MANUAL CHANGE INFORMATION

PRODUCT 832 Instruction
070-2389-00

CHANGE REFERENCE C1/978
DATE 9-1-78

CHANGE REFERENCE C2/978
DATE 9-11-78

DIAGRAM CHANGE

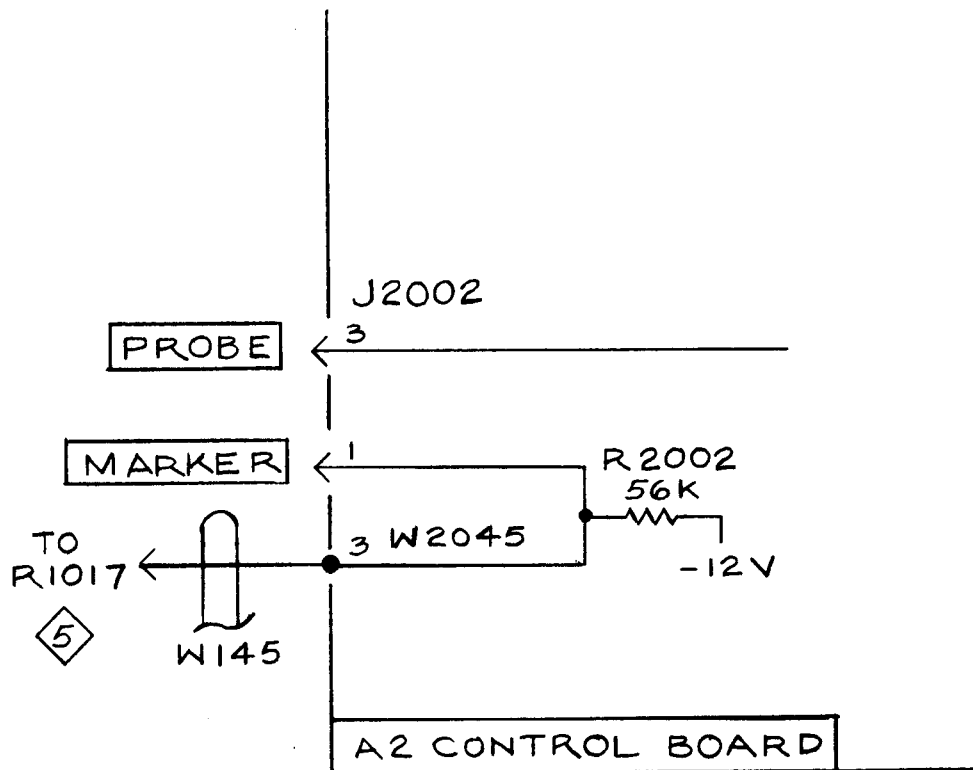
R2002, 56K OHM, 0.25W, 5% resistor to A2 CONTROL board on CONTROL
CIRCUITS diagram 4 as shown below. R2002 is located on back of
A2 CONTROL board.
